REVIEW OF EMERGENCY RESPONSE
CONSIDERATIONS FOR THE VALLEY
CENTER ROAD CORRIDOR CONCEPT
PLAN DESIGN OPTIONS

FINAL REPORT

SAN DIEGO COUNTY

SUPPLEMENT TO THE SEPTEMBER 2023 REVIEW OF
EMERGENCY RESPONSE CONSIDERATIONS FOR THE VALLEY
CENTER ROAD CORRIDOR CONCEPT PLAN DESIGN OPTIONS:
ADDRESSING THE DRAFT FINAL CORRIDOR CONCEPT PLAN

Exhibit 2 – Draft CCP Option B

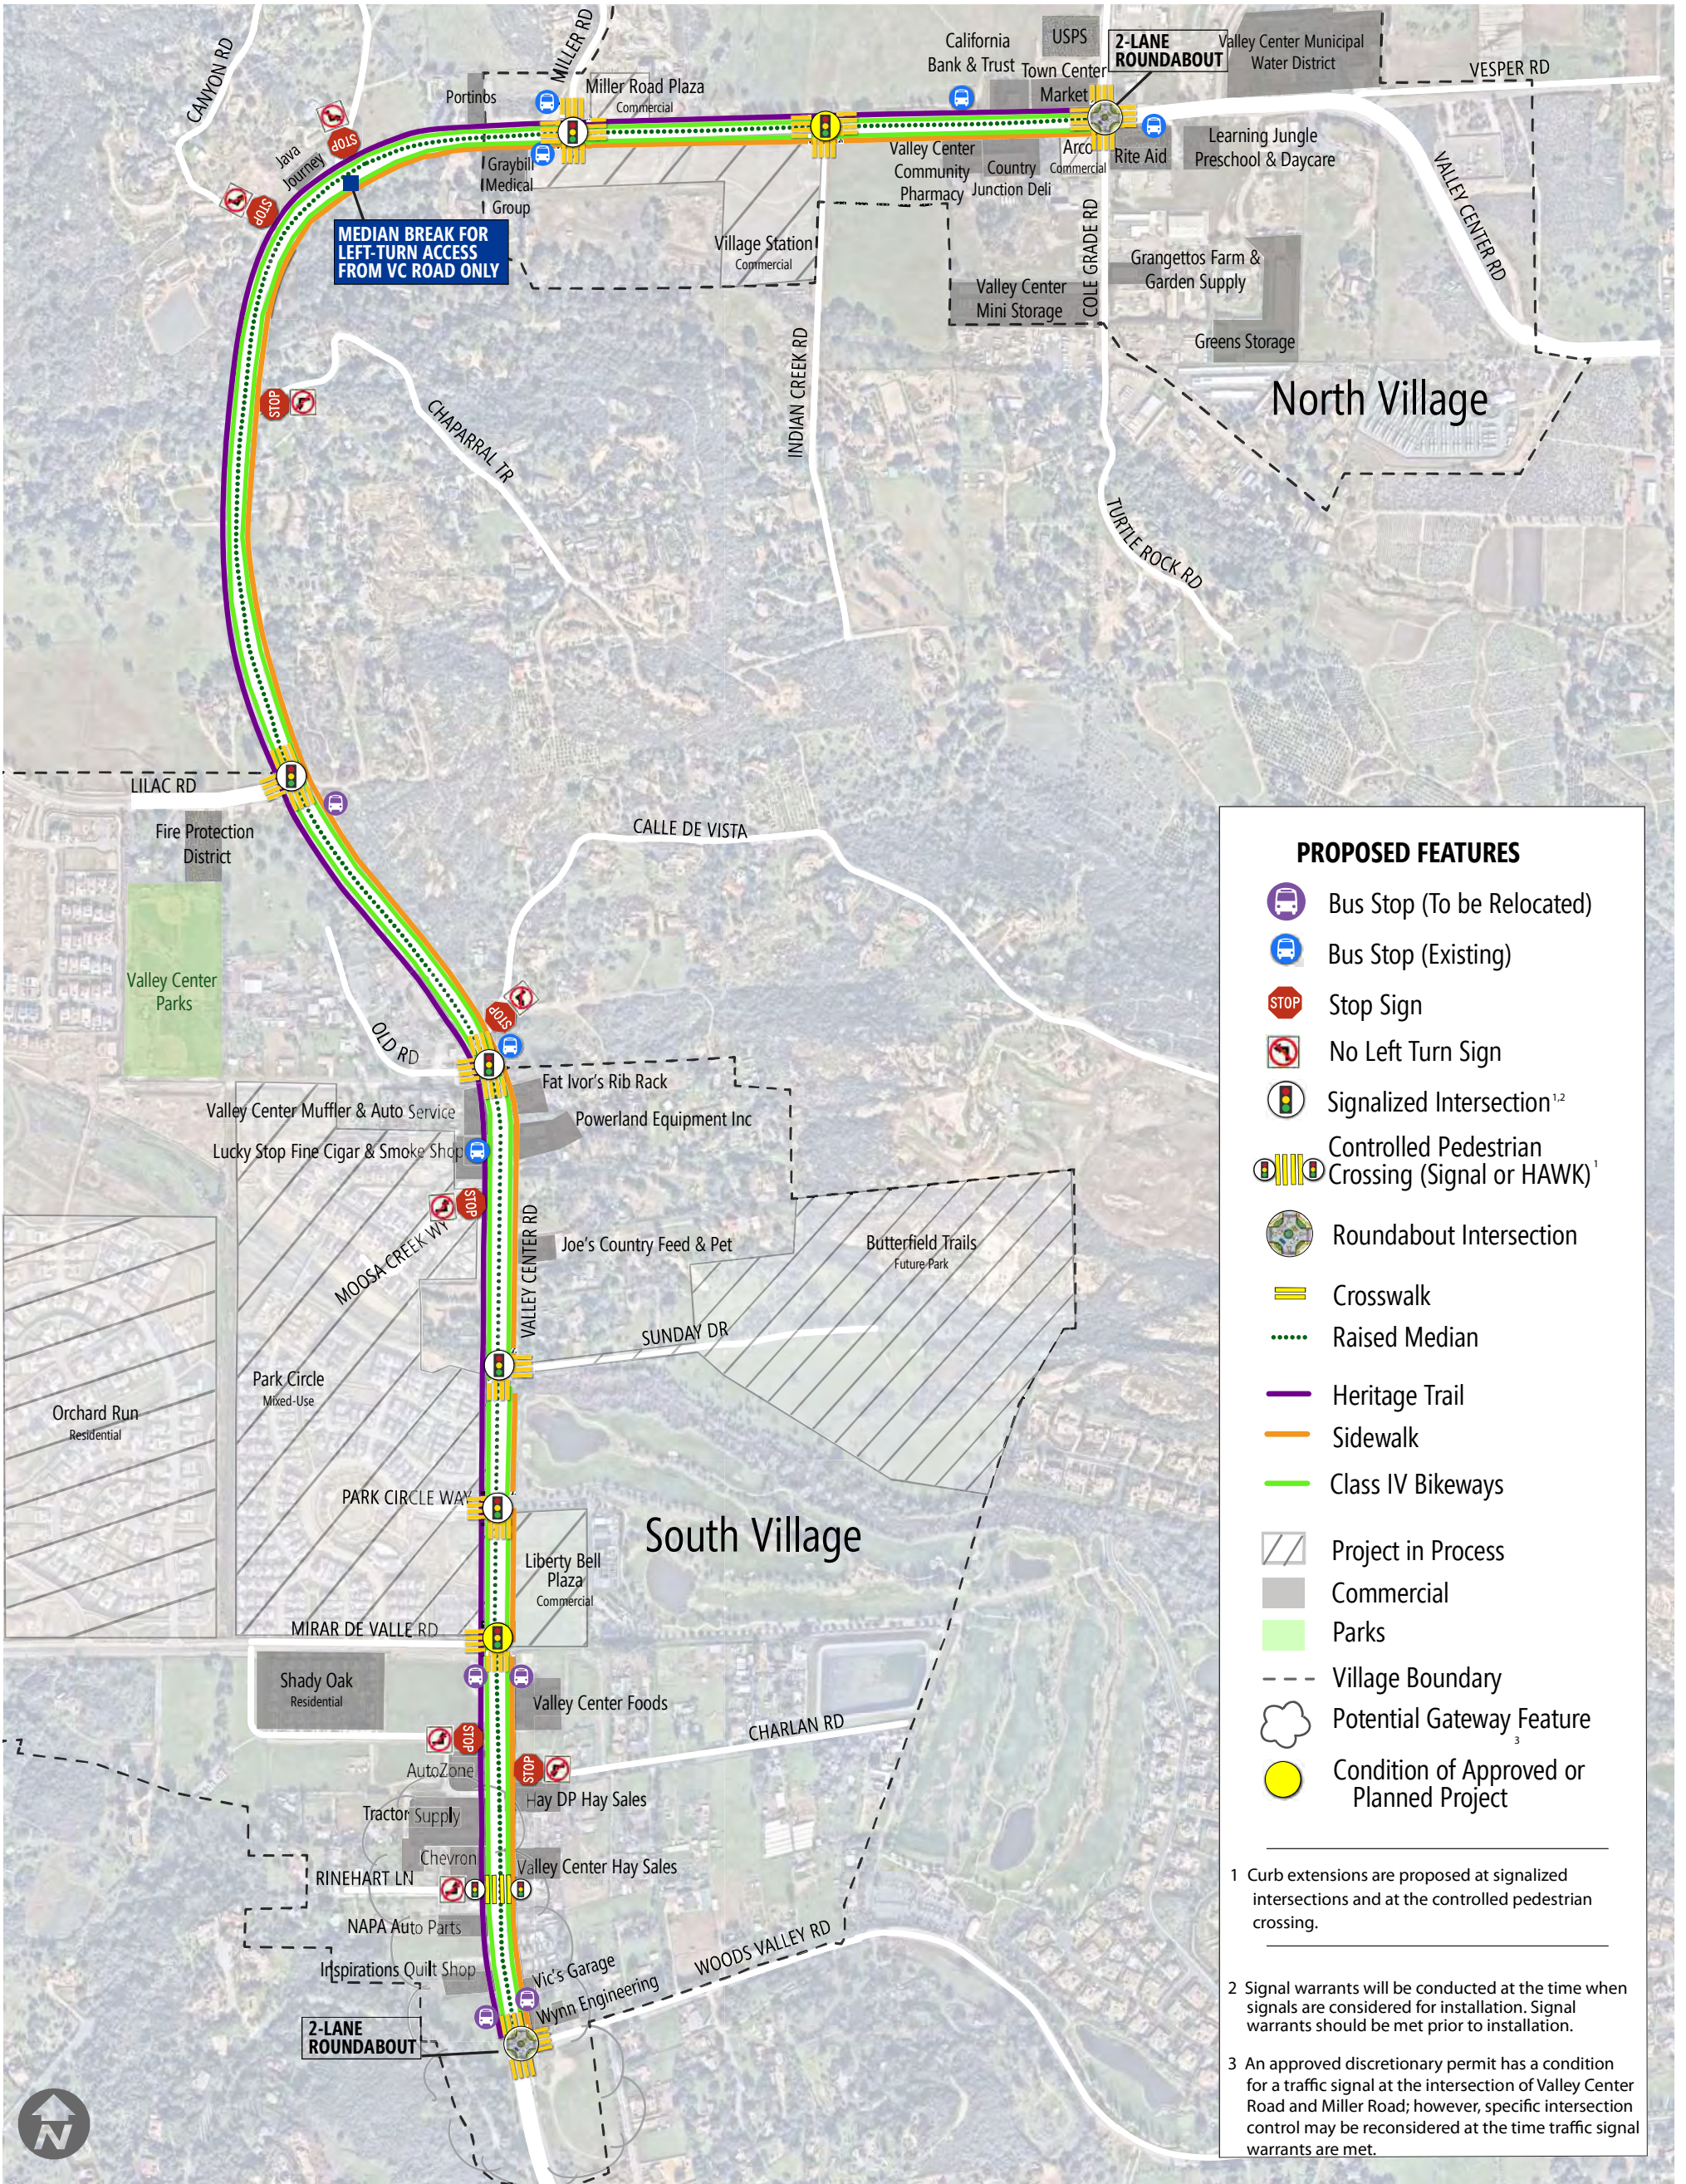
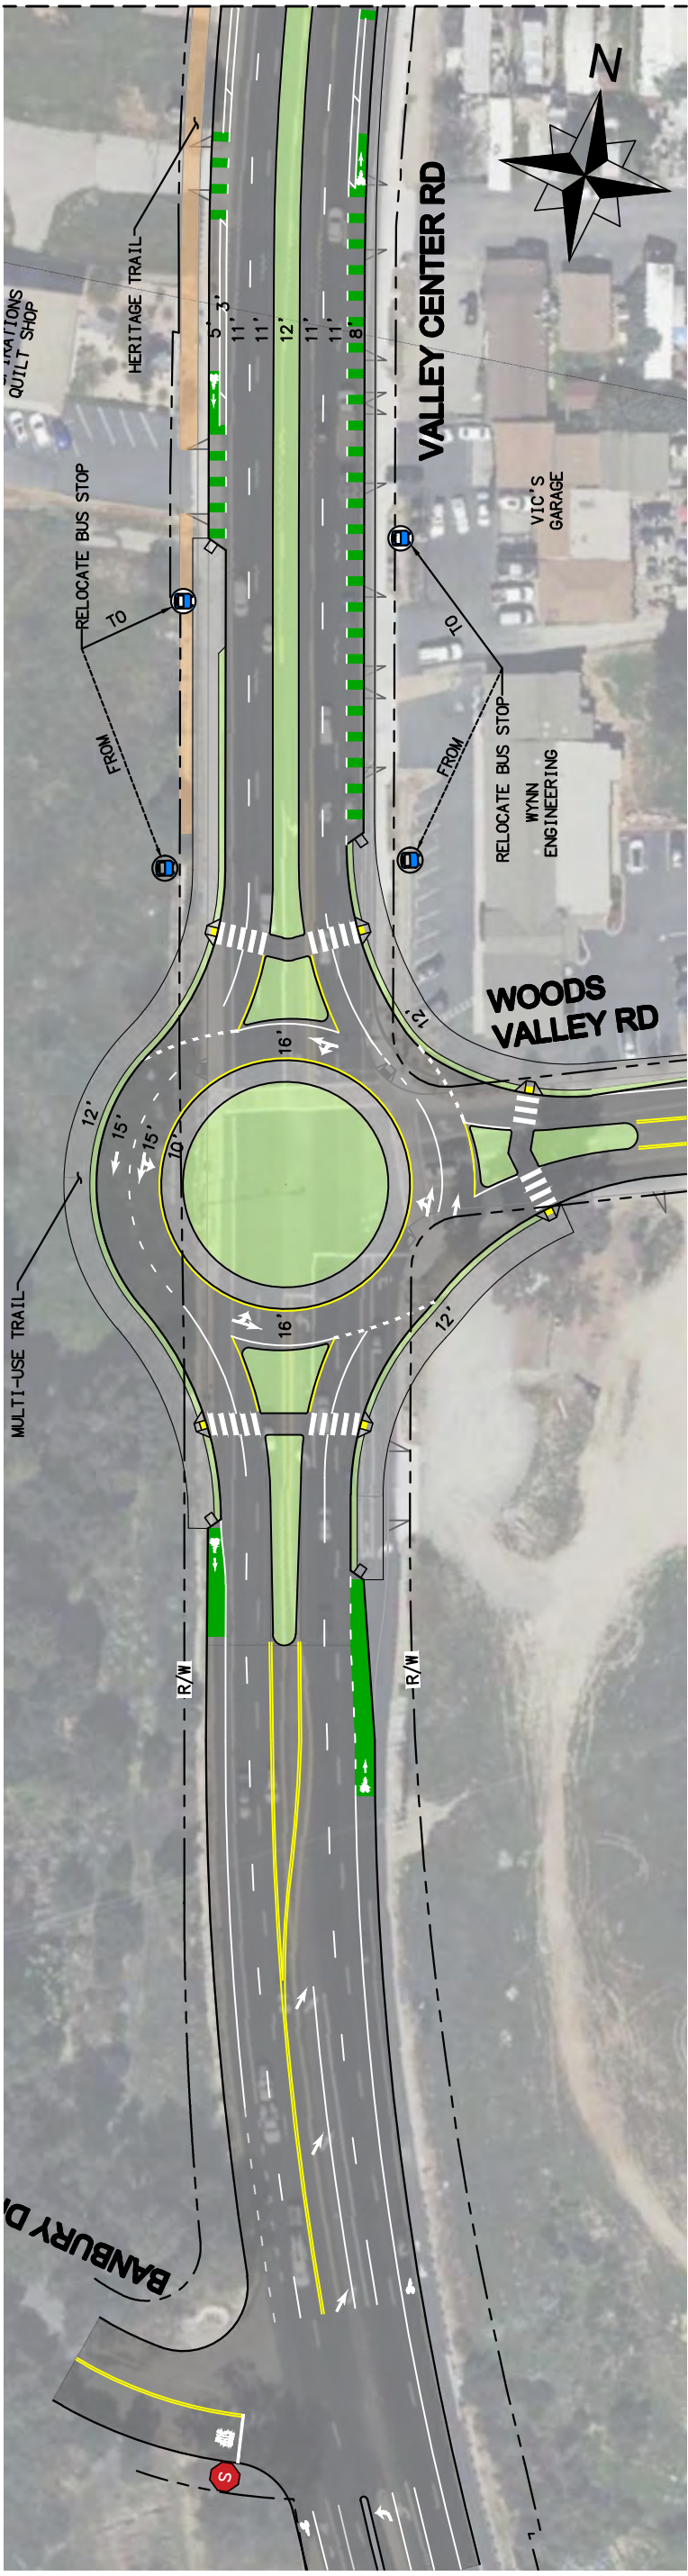
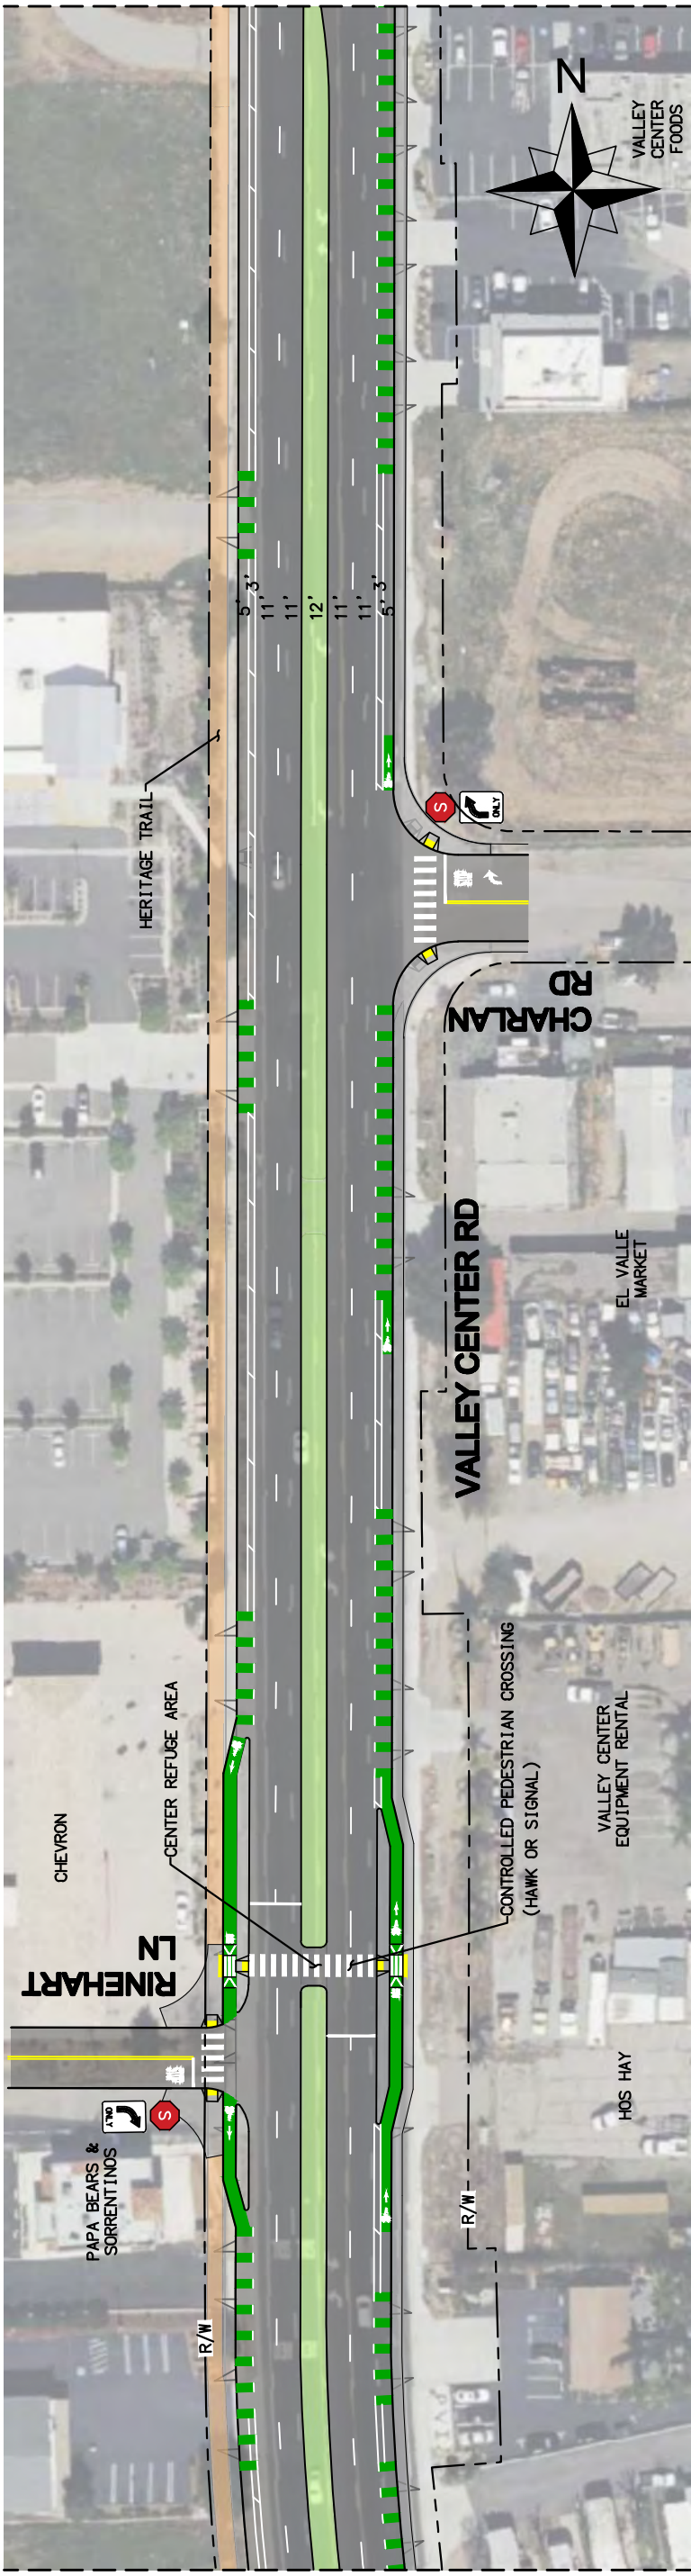
As of June 2023, the County was considering new options for traffic signals and roundabouts in addition to addressing other CCP components for road user safety. Both Option A and Option B—Exhibits 1 and 2 to this report—include the use of seven traffic signals (including two associated with private development requirements and two newly proposed), one pedestrian signal, and two

dual-lane roundabouts. Both options feature roundabouts at Woods Valley Road. Option A has a roundabout at Miller Road and a signal at Cole Grade Road. Option B has a signal at Miller Road and a roundabout at Cole Grade Road.

Citygate observes that, northbound from the fire station on Lilac Road to Cole Grade Road, Option A, with a single roundabout in addition to the other proposed safety controls, is 0:24 seconds slower. Option B is 0:36 seconds slower. A “no roundabout” option is 1:00 minute slower.

Exhibit 4:
Roundabout Turn Template: Aerial Ladder Truck
(Dimensions match the largest VCFPD vehicle)

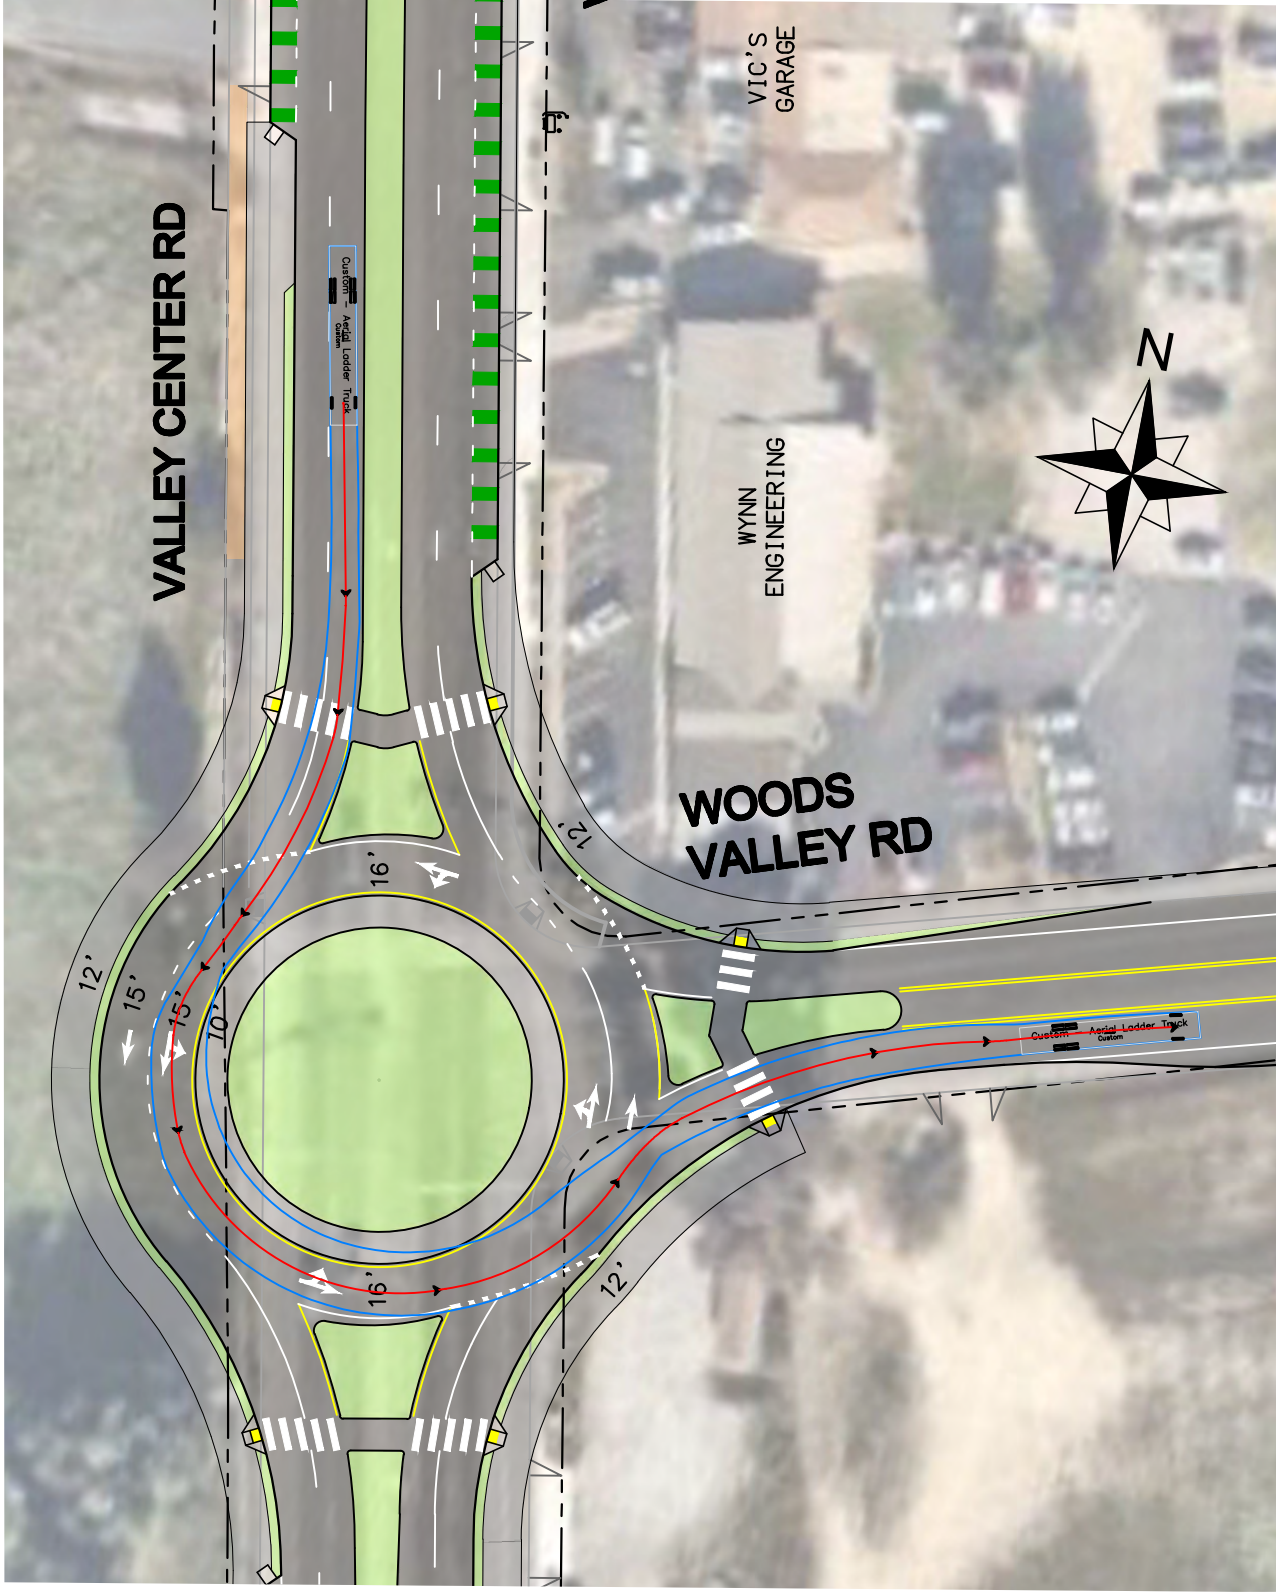
Turn templates have been provided (Exhibits 4, 5, and 6 to this report) to show how large vehicles will be able to navigate the roundabouts, including addressing the dimensions of the largest VCFPD vehicle (aerial ladder truck) and a Cal Fire truck with bulldozer trailer. In reviewing the current literature on roundabouts, Citygate determined the proposed roundabout design to represent best practice for both larger vehicles and higher-volume traffic throughput. Roundabouts may not be as common in the United States as they are abroad, but they are also not rare. Along with our legacy experience with traffic safety design impacts on emergency services, Citygate researched the most recent findings related to roundabouts both in the United States and abroad.
